LUMINARY Memo #148

To: Distribution
From: B. McCoy
Date: 11 May 1970
Subject: Call It LUMINARY 1D

Revision 163 of Luminary was released on 5/5/70 for manufacture. It contained a total of 39 PCRs, 6 PCNs, 15 ACBs and 6 Anomalies. On the following pages is a detailed description of each implementation or a reference made where appropriate.

R10 COMPUTATIONS in SERVICER

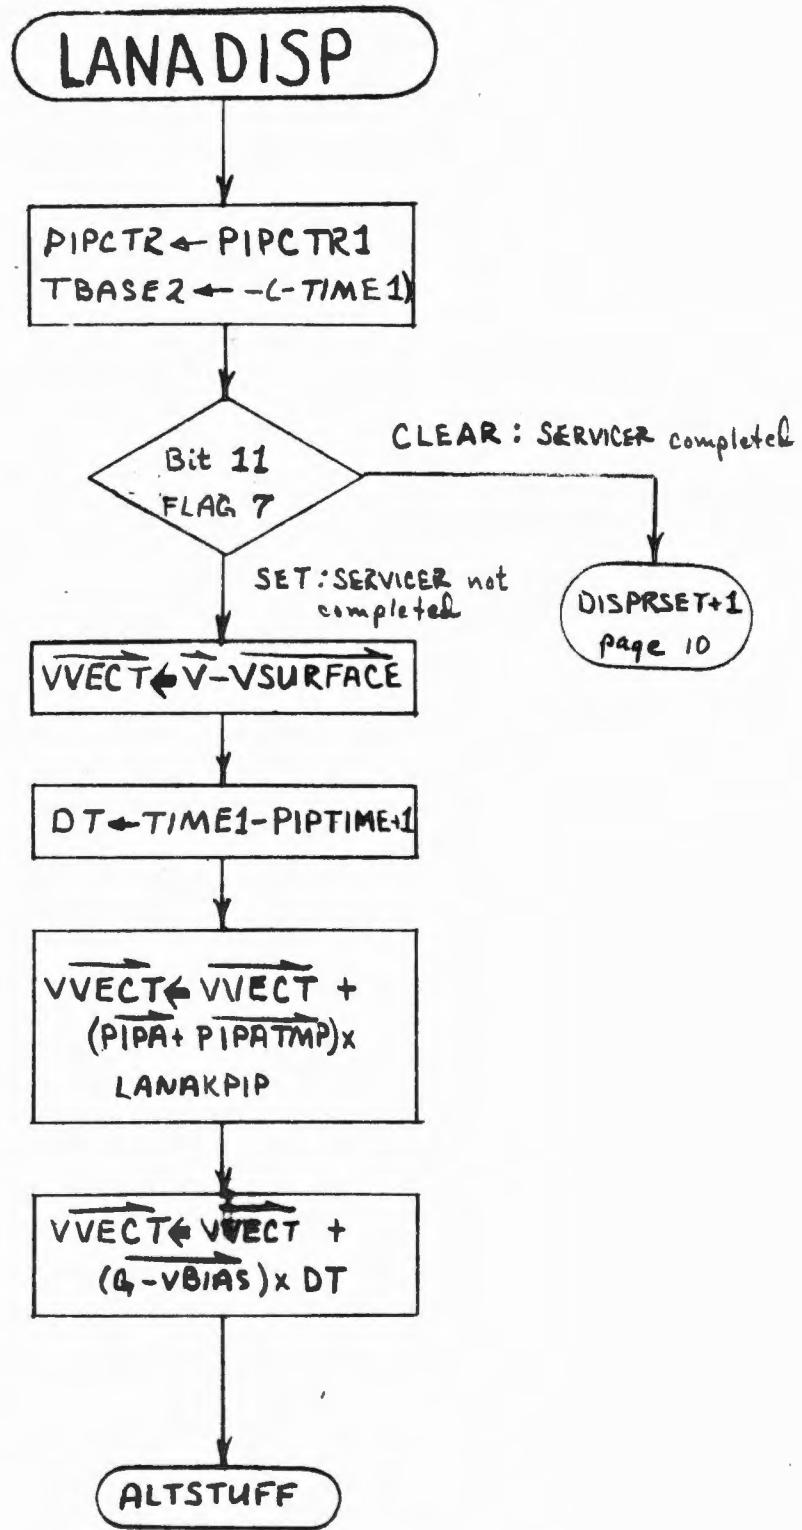
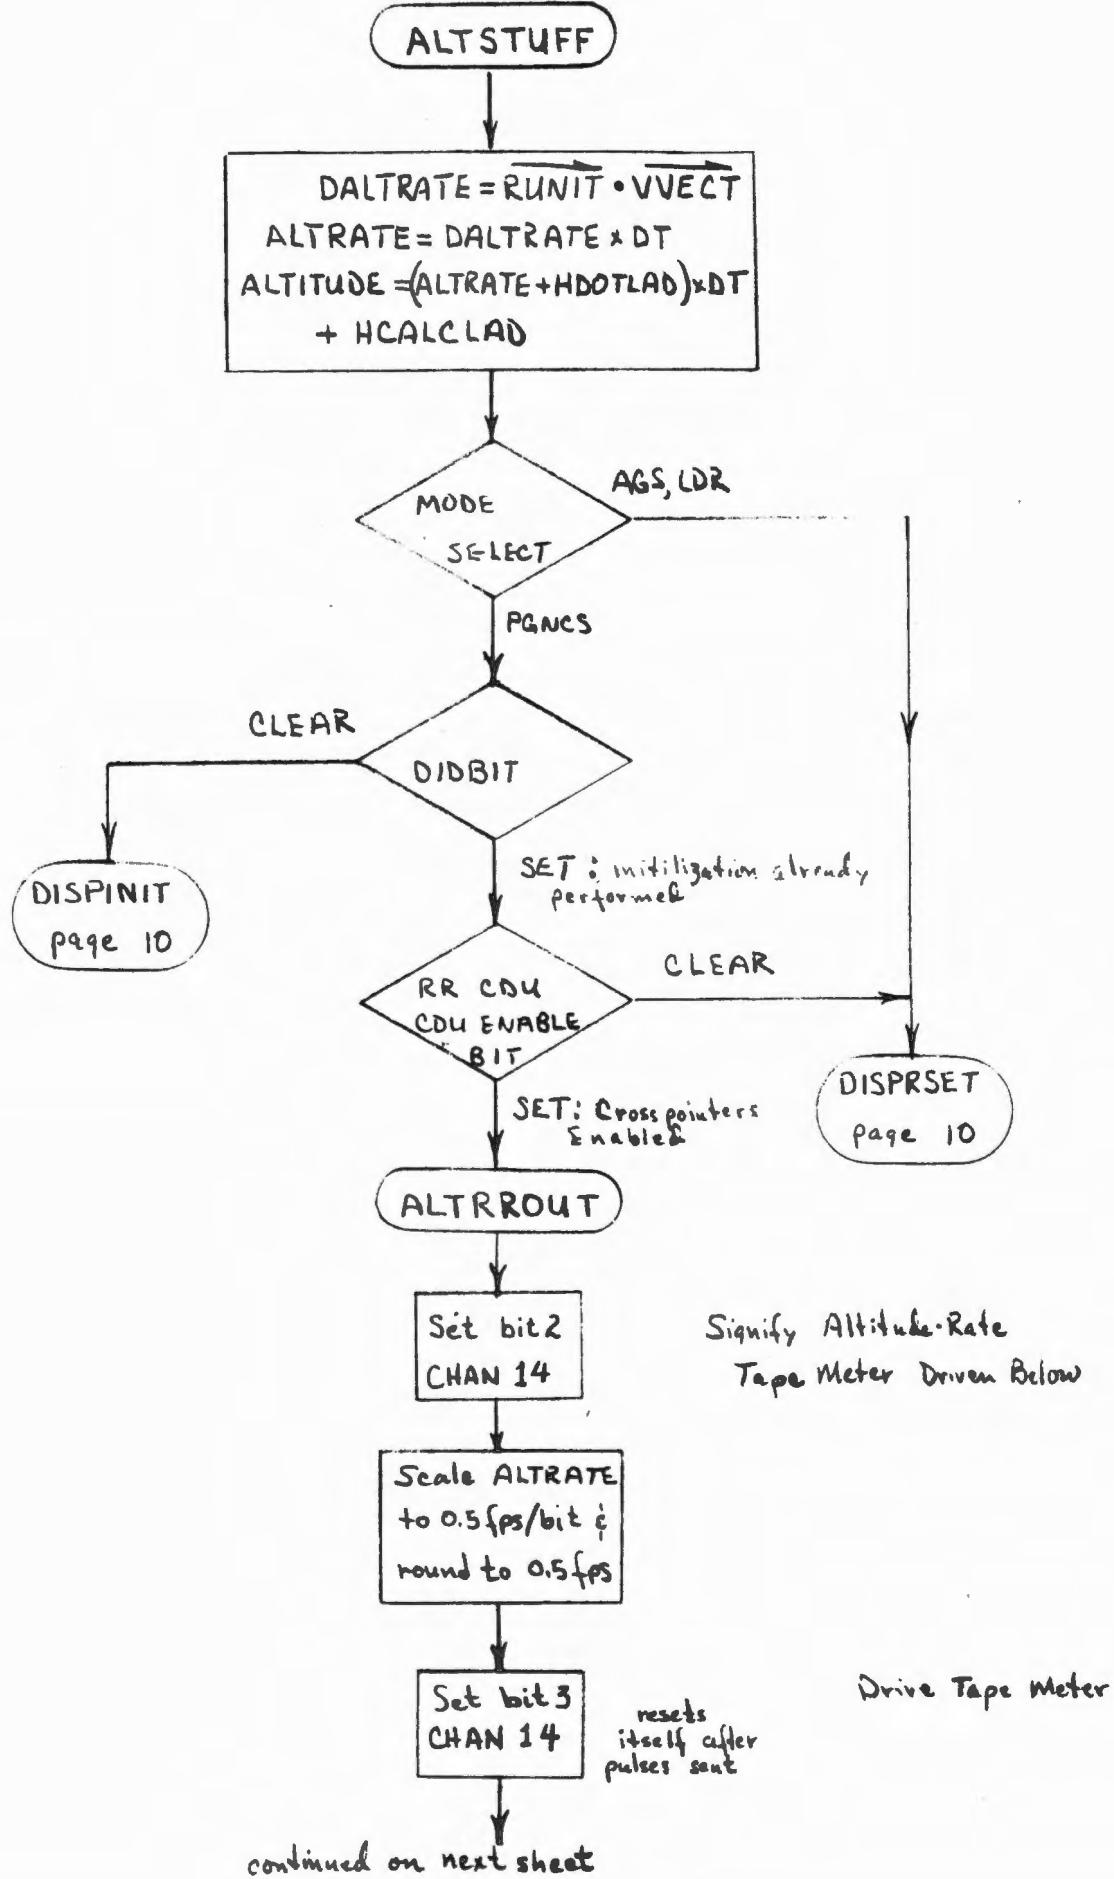
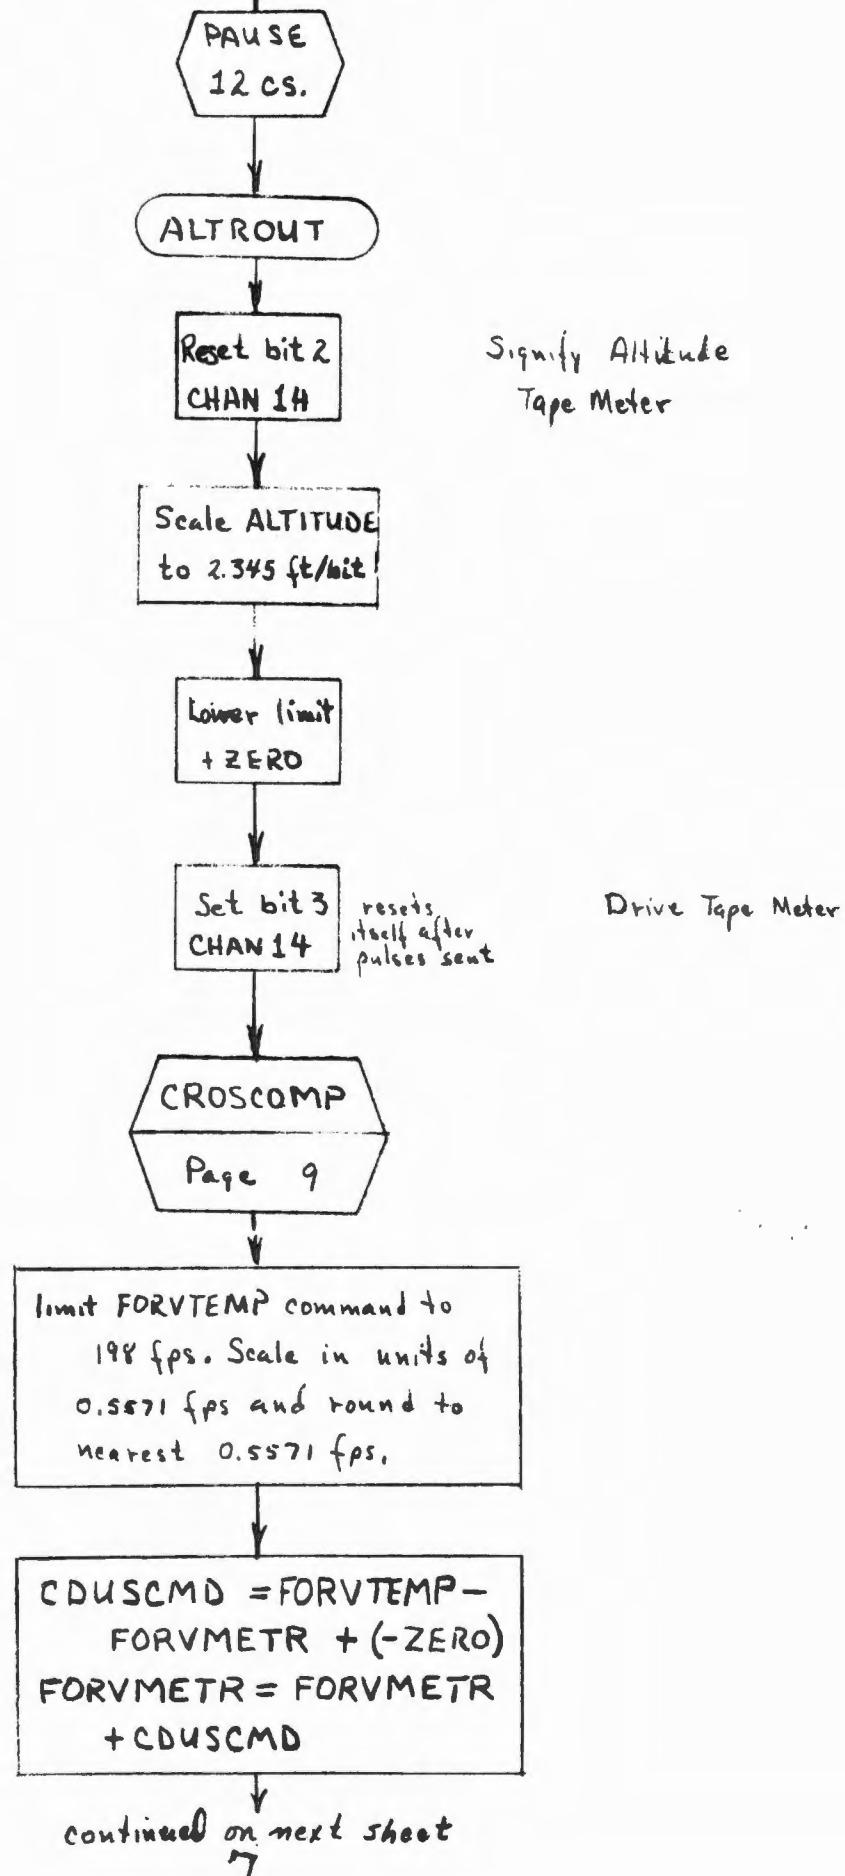
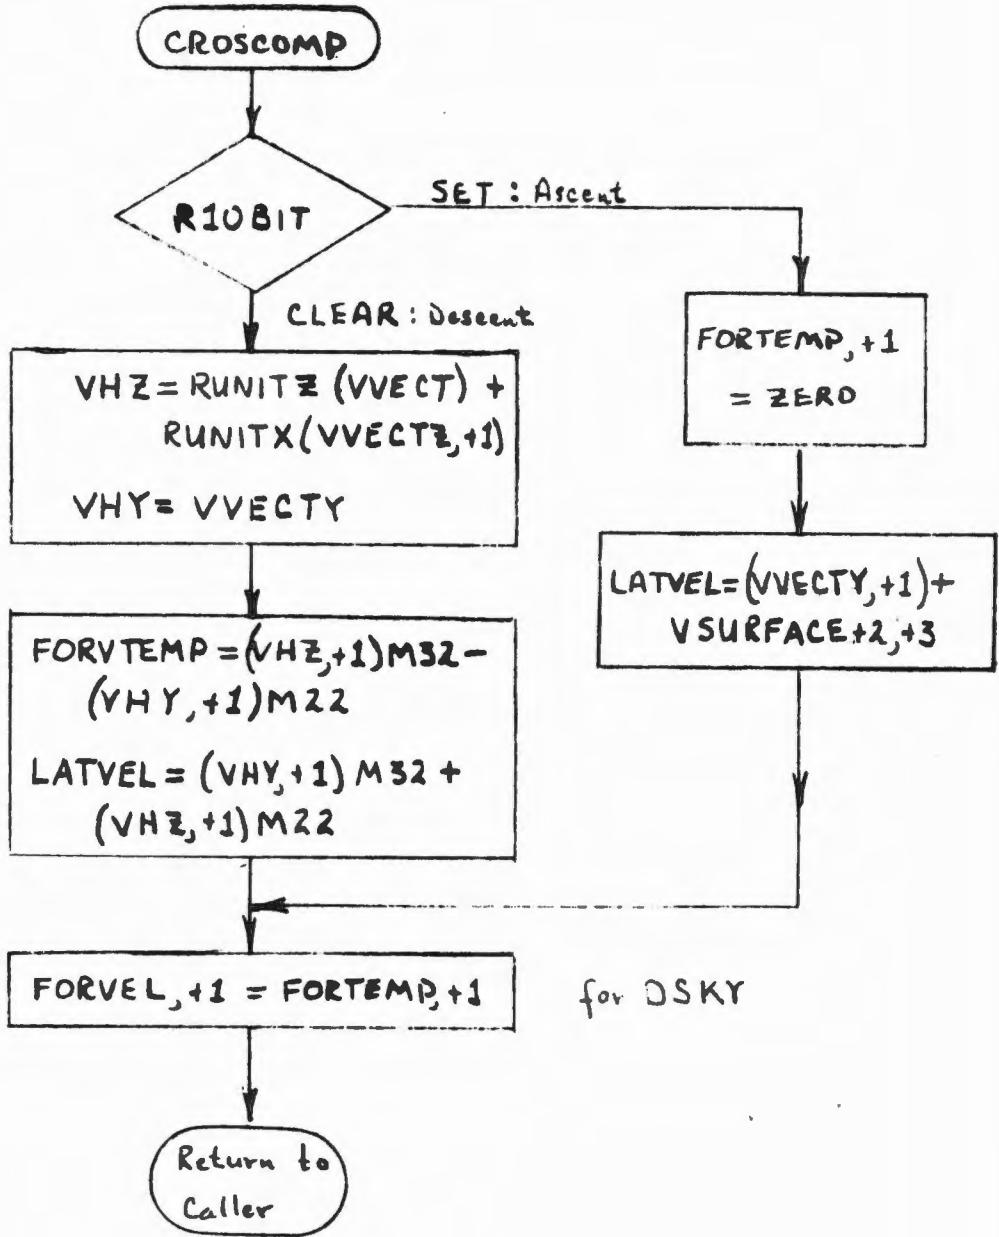
PCR 1058: When it was found that the Landing Analog Displays Routine (R10) gave results with errors up to 3.5 fps in the cross pointer display, a new R10 was suggested to effectively eliminate these errors. In the process the altitude-rate glitch was eliminated. The word saving was 119 words; the new R10 takes 1% longer. The main cause of the errors was the single precision dot products; these were changed to double precision. Also, some computational simplifications were made to the dot products, knowing that the IMU is aligned to the landing site. A PIPA bias correction term is added to increase accuracy; computation of VBIAS formerly done in P66 is now done in SERVICER. Altitude is based on a simpler extrapolation than before. R10 now computes altitude and Alt-Rate every pass (every 1/4 second) outputting Alt-Rate before a 12 cs pause, Altitude immediately after the pause. Flag bit SWANDISP is now set immediately after SERVICER computes the parameters necessary for R10 so that R10 may start near TIG -30 rather than at ignition. The DIDFLAG definition remains the same; just DID the initialization. IMODES33 bit 7 is no longer used. ACB L-11 and Anomaly L-1B-04 were not incorporated into the new R10 as originally conceived, but they are in Luminary 178: The forward velocity for NOUN 60 will be computed if the MODE SELECT switch is not in PGNCS (and incidentally accurate to 0.1 fps); R10 will be initialized if the RR CDU ENABLE bit is removed by e.g. moving the RR MODE switch into and out of LGC.

Flow Charts for R10 and its interface parameter computation are attached. For more details see Luminary Memo #162 by Don Eyles. This memo superceeds Memo #162 where differences occur.

limit LATVEL command to
198 fps. Scale in units of
0.5571 fps and round to
nearest 0.5571 fps.

CDUTCMD = LATVEL -
LATVMETR + (-ZERO)
LATVMETR = LATVMETR +
CDUTCMD

ANOMALY # L-10-05

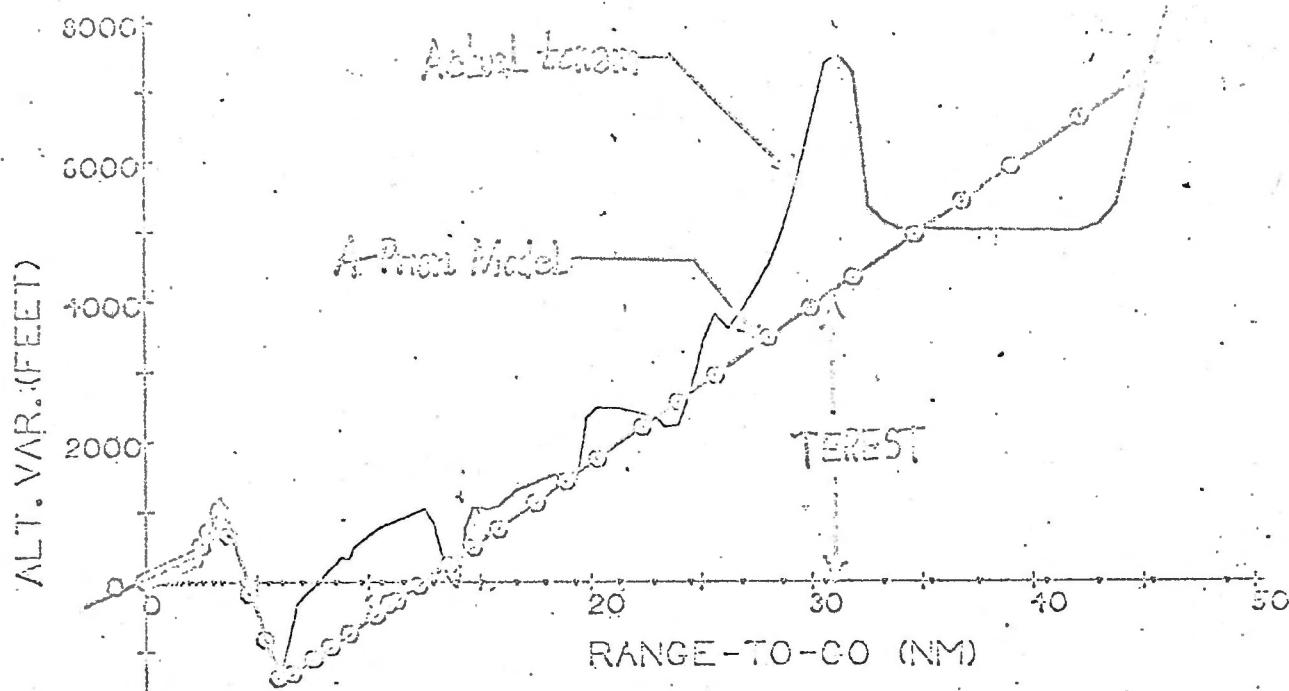
$$\begin{aligned} h' &= \underline{r}_P - \underline{r}_{SP} \\ \delta h &= \tilde{h} - h' + TEREST \\ \underline{r}_P &= \underline{r}_P + w_H \delta h \underline{u}_{HP} \end{aligned}$$

The quantity h' is the a-priori altitude estimate, w_H is the LR altitude weighting function, and \underline{u}_{HP} is a unit vector along the local vertical. It is assumed in the δh relation that the sign of TEREST is positive when a terrain point higher than the site is being modeled.

Figure 3.3-11 Time-to-go Predictor Routine

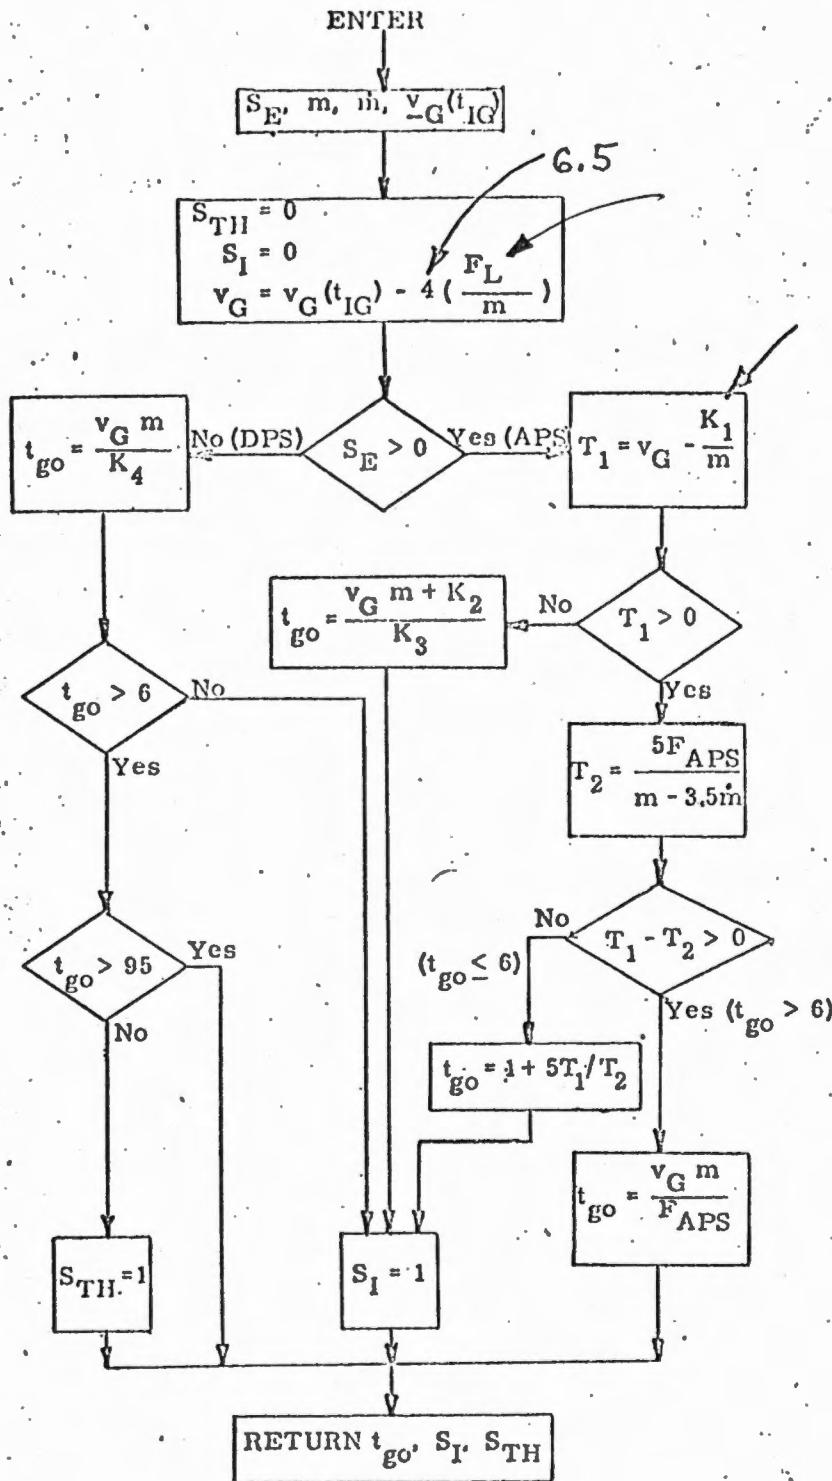
1.6 DESCRIPTION OF CHANGE <ol style="list-style-type: none"> 1. Turn on ullage at TIG-6 sec. in P42; assume 6.5 sec. in Routine S40.13. 2. Change K1VAL from 2800 to 3150 lb. sec. in Routine S40.13 3. Change Thrust Ullage (FL) from 200 to 400 lbs. in Routine S40.13

The initial computation in Fig. 3.3-11 estimates the velocity-to-be-gained after $\frac{6}{5}$ seconds of ullage. If the DPS were selected (P-40), the maneuver time, t_{go} , is then computed on the basis of 10% thrust. If this time is less than 6 seconds no active guidance steering is attempted ($S_I = 1$) and the vehicle attitude is maintained at the pre-thrust alignment throughout the maneuver. If the DPS t_{go} is greater than 95 seconds normal steering will

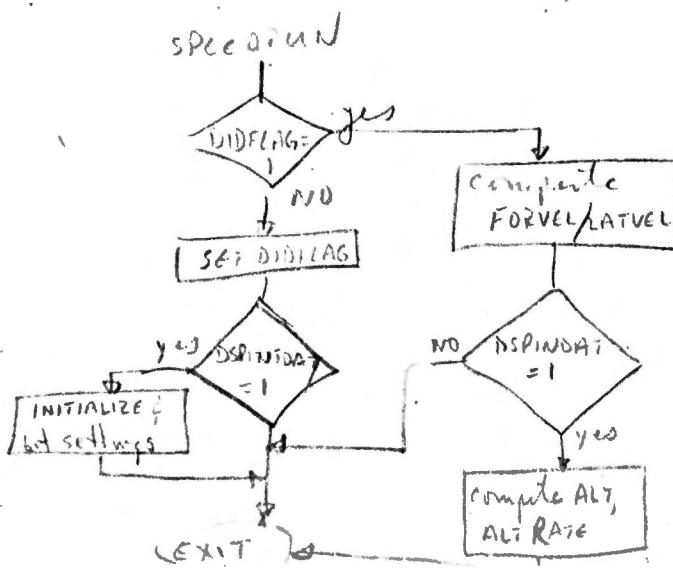
Change the coding in SPEEDRUN (during SERVICER) to compute LATVEL and FORVEL regardless of position of MODE SELECT switch - addition of sideways

The FORWARD VELOCITY (FORVEL) is not computed for display on Xpointer or for use as one of the MODE SELECT (which controls which system will display on the X pointer or tape reader) settings at any position but ~~THIS~~ PGNCS
